रेल डिब्बा कारखाना, कपूरथला
RAIL COACH FACTORY, KAPURTHALA

MD35131 **Date:31.01.2026**

Sub: Issue of corrigendum-1 to **MDTS-39424 Rev.01** Purchase Specification for HS-SPART

Following is the corrigendum to MDTS-39424 Rev.01**(Purchase Specification for HS-SPART)** for information and necessary action at your end:

SKETCH-1

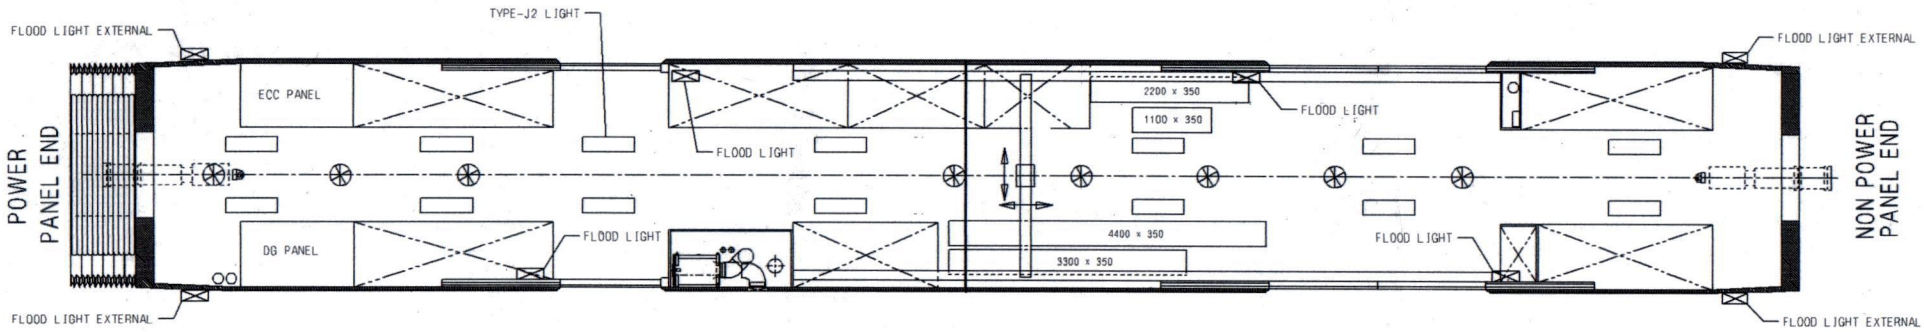
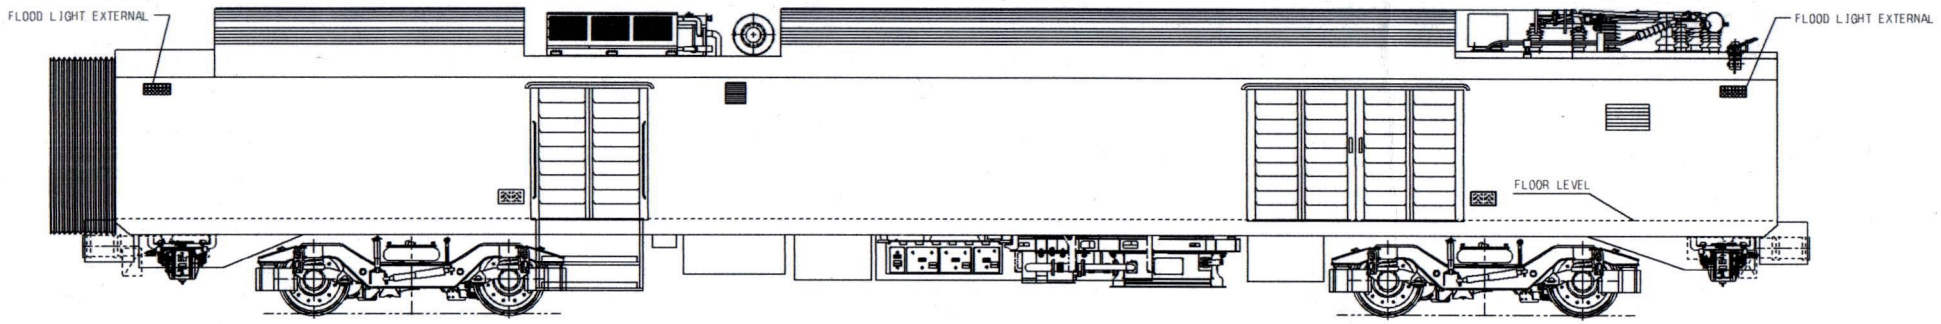
LED LIGHT FITTING B1	18 NOS.
FLOOD LIGHT	04 NOS.
DISASTER MANAGEMENT(DML)	04 NOS.
CAB LIGHT	04 NOS.
SPOT LIGHT	02 NOS.
SIGNAL EXCHNAGE LIGHT	02 NOS.
LAVATORY LIGHT	06 NOS.
MOBILE CHARGING SOCKET (MCS)	08 NOS.

NOTE: PROPOSED TENTATIVE LOCATION AND QPC OF LIGHTS & SOCKETS

a) Arrangement of Light fittings and Mobile charging sockets shall be as per SKETCH-1, 2 ,3 & 4 (enclosed).

c) Wiring shall be provided by Propulsion system supplier as per the location of Lights and Mobile charging sockets shown in SKETCH -1, 2,3 & 4. In case, location of any Light fitting or Mobile charging socket is changed by Furnishing contractor, design review shall be carried out with Electrical Design/Propulsion system supplier.

SKETCH-2

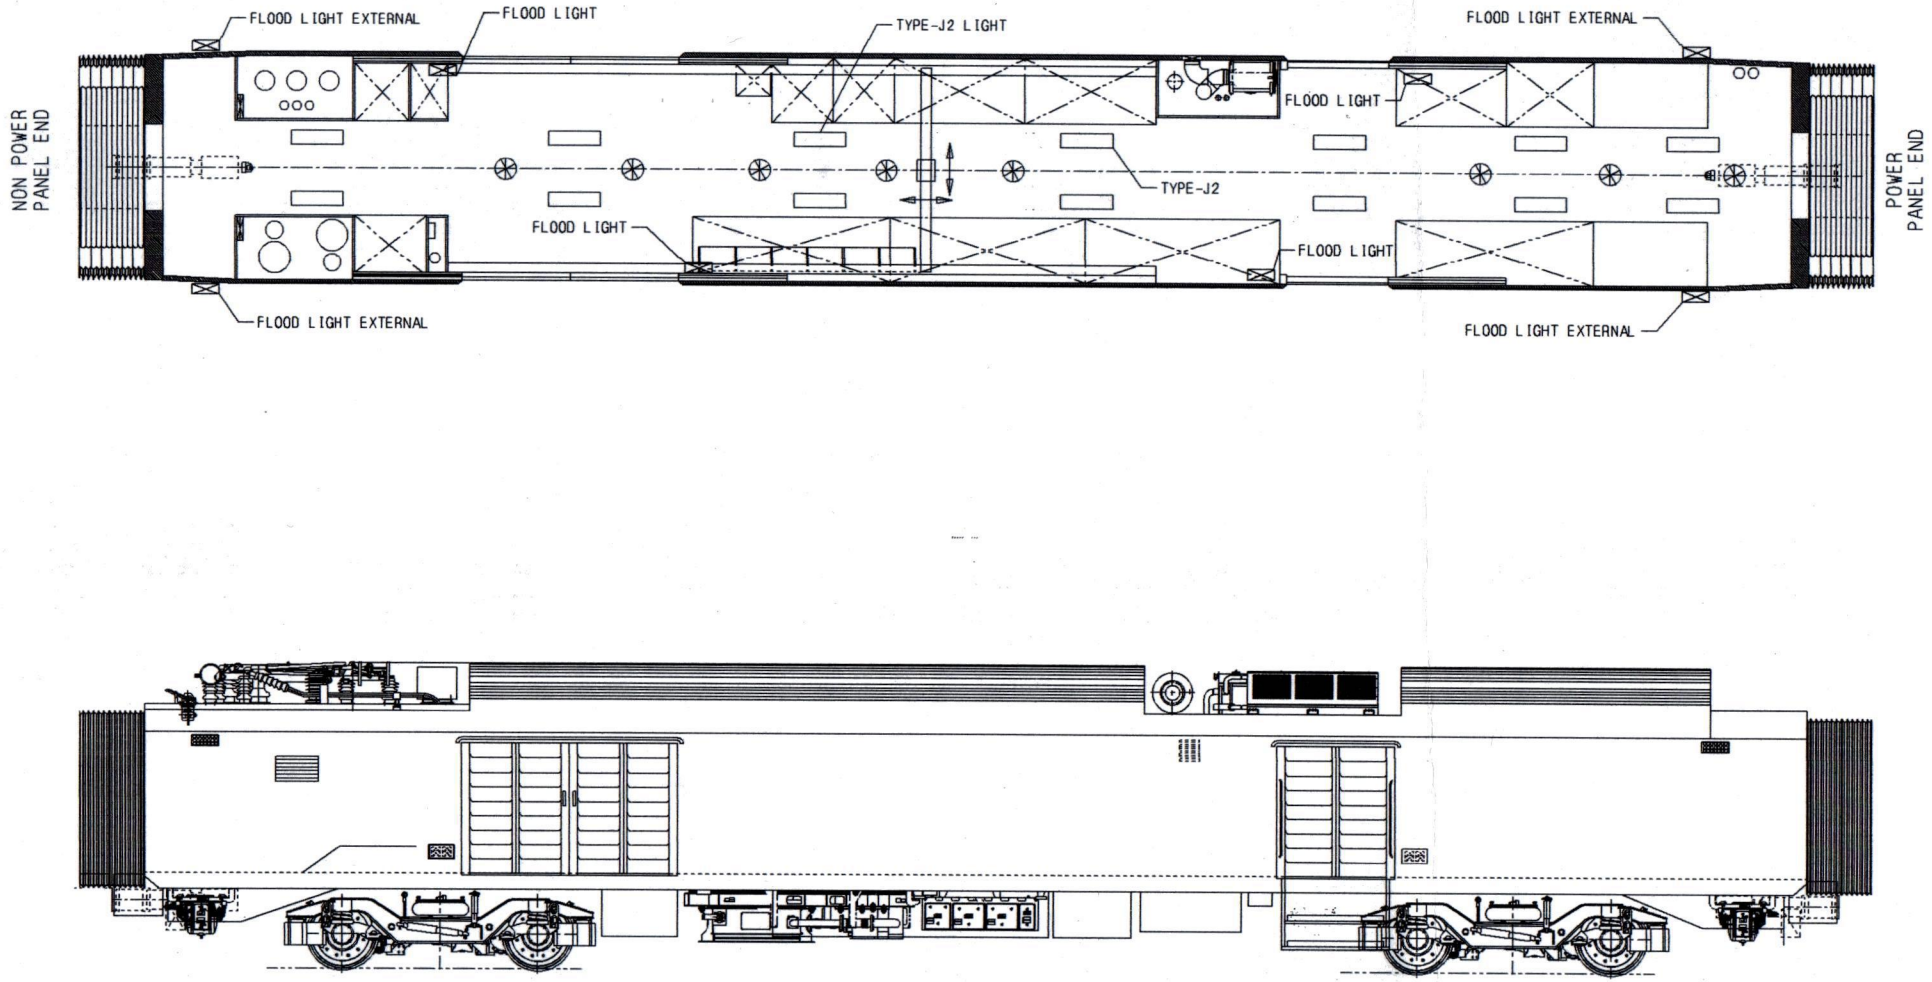
FLOOD LIGHT EXTERNAL	4 NOS.
FLOOD LIGHT INTERNAL	4 NOS.
TYPE-J2 LIGHT	14 NOS.

NOTE: PROPOSED TENTATIVE LOCATION AND QPC OF LIGHTS

SKETCH-3

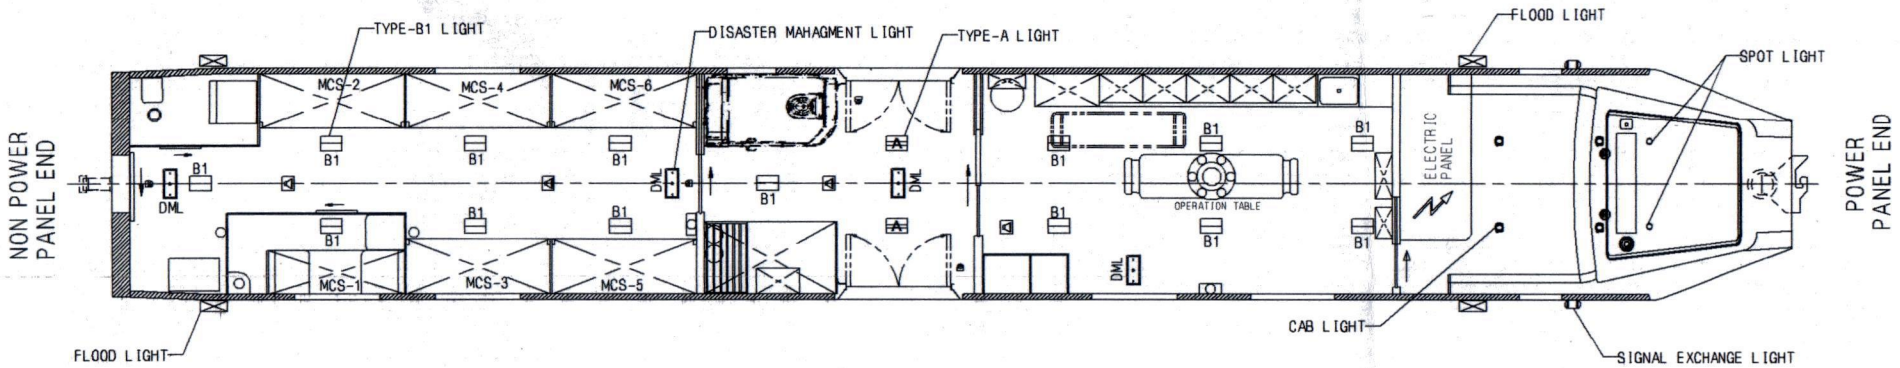
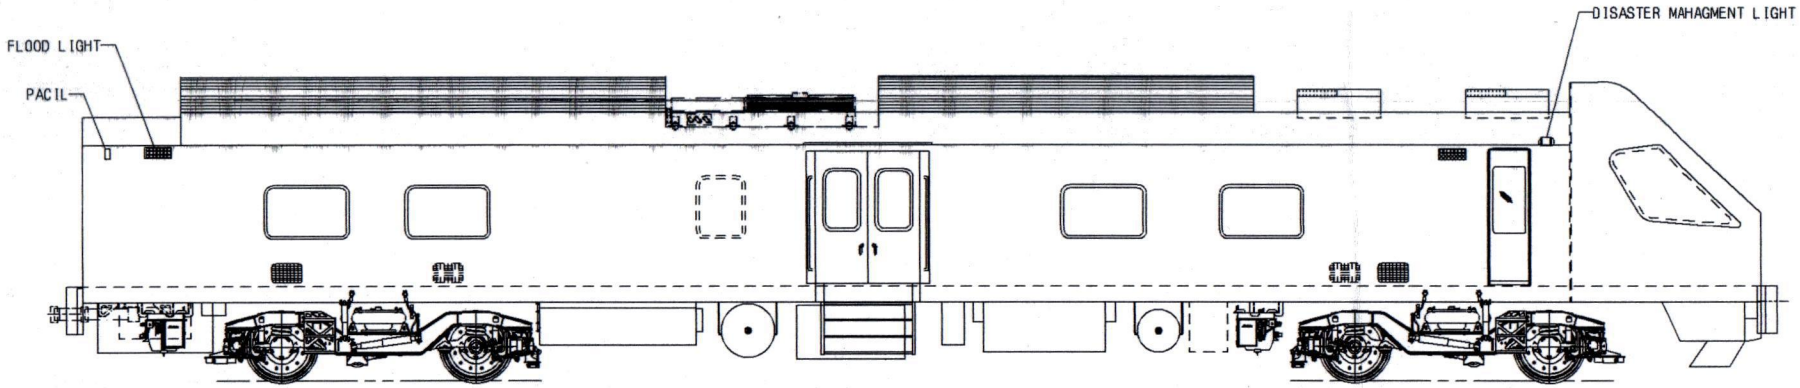
FLOOD LIGHT EXTERNAL	4 NOS.
FLOOD LIGHT INTERNAL	4 NOS.
TYPE-J2 LIGHT	14 NOS.

NOTE: PROPOSED TENTATIVE LOCATION AND QPC OF LIGHTS
